# Access Compliance Report

## Public Rights-of-Way

### (Curb Ramps)

Intersection ID: 42554	Main Street: ENEIDA_SUE_DR	Cross Street: TODDVILLE_RD	Location:	N
ADA ID: 3B86CF0CE510	Ramp Type: Perp	Initial Pass/Fail: Fail	Overall Compliance: No	Severity Score: 1.25

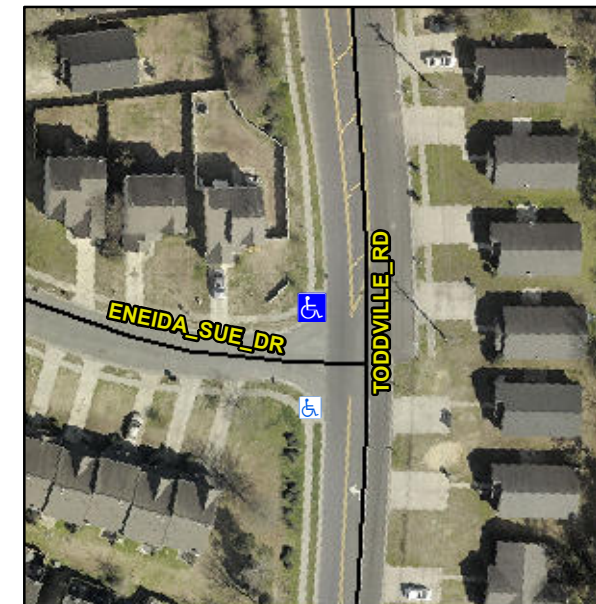
**Not Found, R304.5.3**

Compliance	Description	Data	Compliance	Description	Data
N/A	Ramp Length (in)	48.0	Yes	Ramp Slope (%)	6.5
Yes	Ramp Width (in)	58.0	No	Ramp XSlope (%)	2.1
N/A	Flare Type LT	N/A	N/A	Flare Type RT	N/A
N/A	Flare Slope LT (%)	N/A	N/A	Flare Slope RT (%)	N/A
N/A	Flare Traversable LT?	N/A	N/A	Flare Traversable RT?	N/A
N/A	Landing Length (in)	N/A	N/A	DWS Provided?	N/A
N/A	Landing Width (in)	N/A	N/A	DWS Contrast?	N/A
N/A	Landing Slope (%)	N/A	N/A	DWS Length (in)	N/A
N/A	Landing X Slope (%)	N/A	N/A	DWS Full Width?	N/A
N/A	Landing Curb? (Y/N)	N/A	N/A	DWS Offset (in)	N/A
N/A	Shared Landing?	N/A			
N/A	Gutter Ponding?	N/A	N/A	Gutter Slope (%)	N/A
N/A	Gutter Lip Ht (in)	0.5	N/A	Gutter X Slope (%)	N/A
N/A	Painted X Walk1?	No	N/A	Painted X Walk2?	N/A
	X Walk 1 Direction	To S		X Walk 2 Direction	N/A
N/A	X Walk 1 Width (in)	N/A	N/A	X Walk 2 Width (in)	N/A
	X Walk 1 Slope (%)	0.1		X Walk 2 Slope (%)	N/A
	X Walk 1 X Slope (%)	4.1		X Walk 2 X Slope (%)	N/A

**Remove & Replace Entire Ramp.**
